DEVELOPMENT REVIEW COMMITTEE

CASE COMMENT REPORT

CASE NO. UDP-S24021

CASE:	UDP-S24021
MEETING DATE:	April 23, 2024
REQUEST:	Site Plan Level III Review: Conditional Use for Building Height Exceeding 75 Feet, Alternate Design Request, and Associated Parking Reduction for 974-Unit Multifamily Residential Development in the Uptown Area
APPLICANT:	Cypress Development, LLC.
AGENT:	Stephanie Toothaker, Esq.
PROJECT NAME:	Cypress Development
PROPERTY ADDRESS:	150 NW 68th Street
ZONING DISTRICT:	Residential Multifamily Mid Rise/Medium High Density District (RMM-25)
LAND USE:	Employment Center
COMMISSION DISTRICT:	1 - John Herbst
NEIGHBORHOOD ASSOCIATION:	N/A
CASE PLANNER:	Jim Hetzel

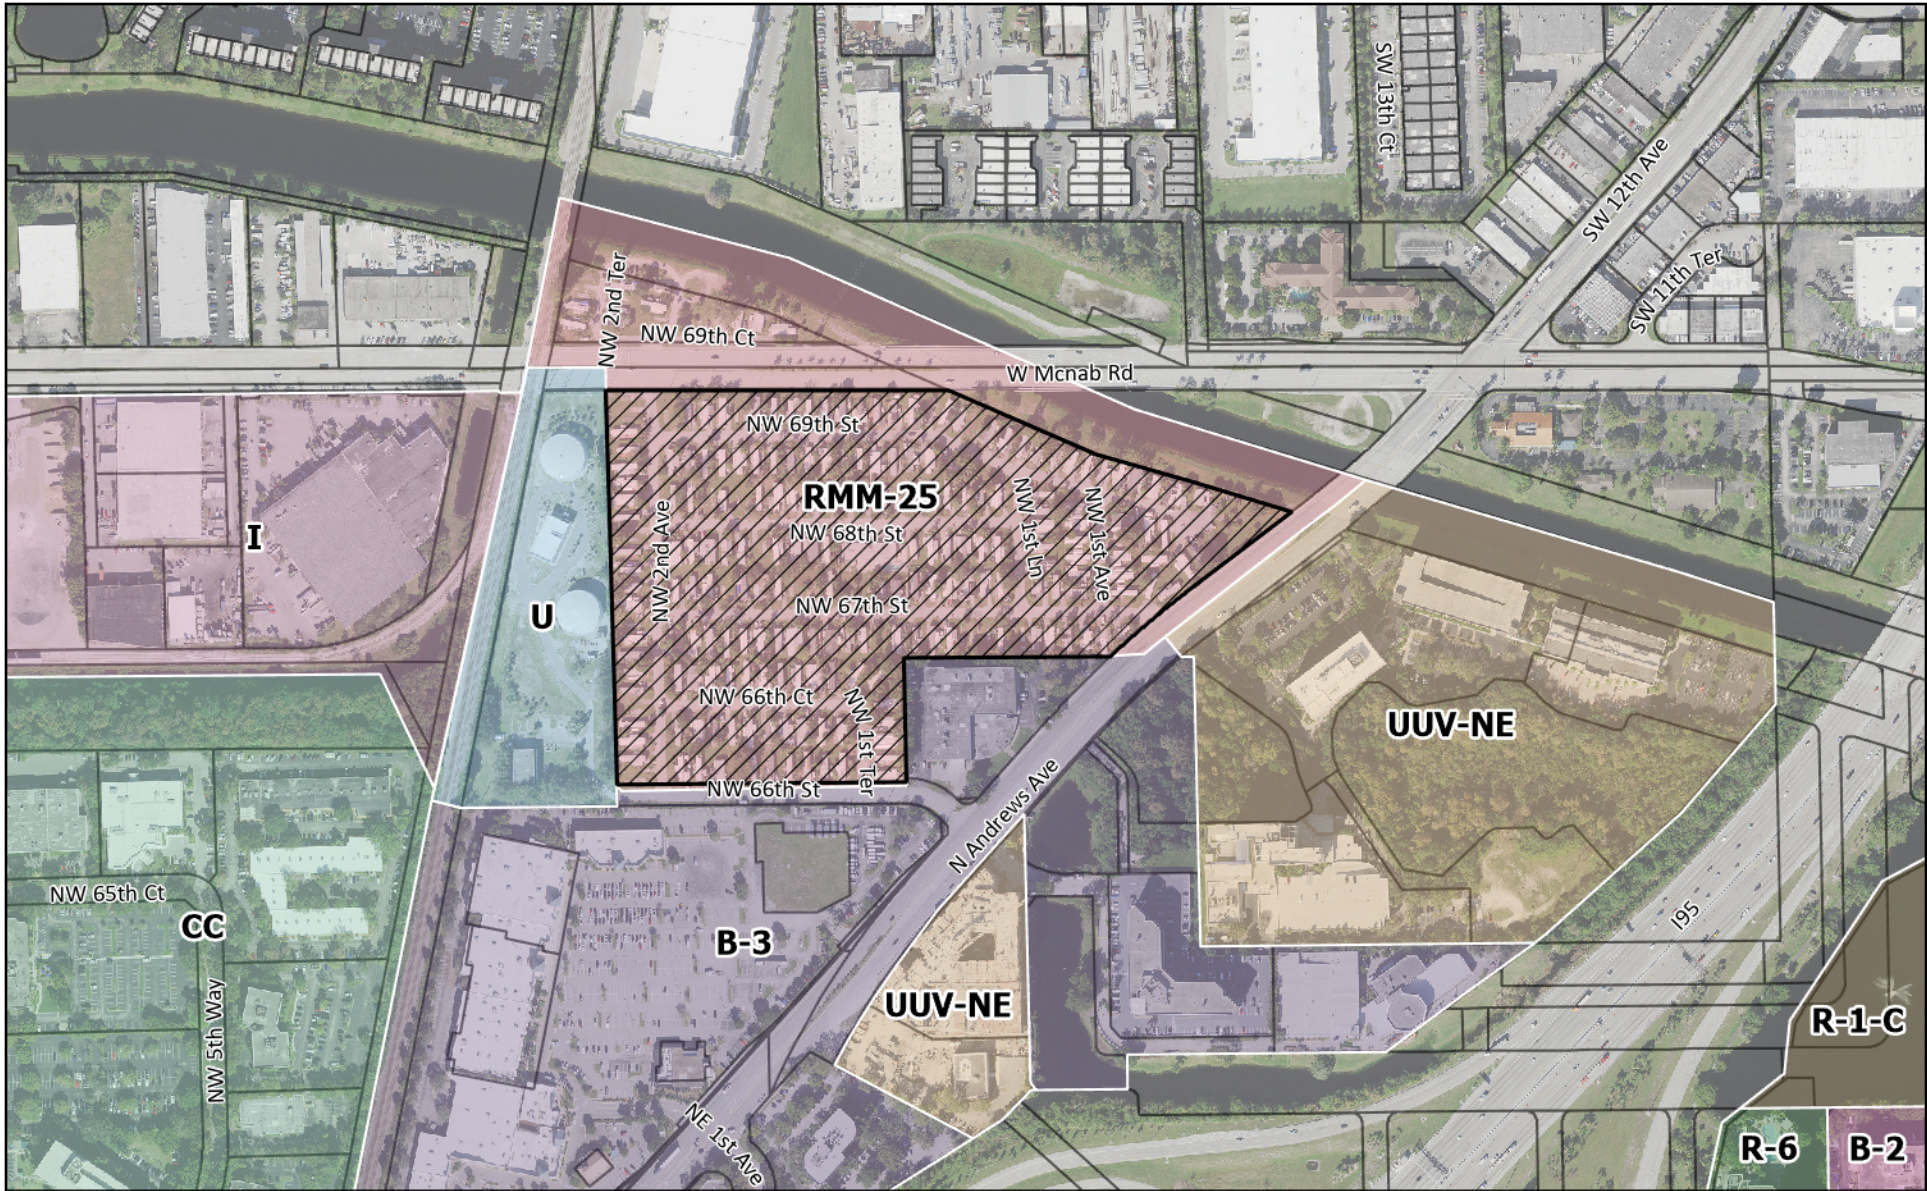
f. Project does not meet the intent for open space requirements, building design, mixed use development site layout, and sense of place elements.
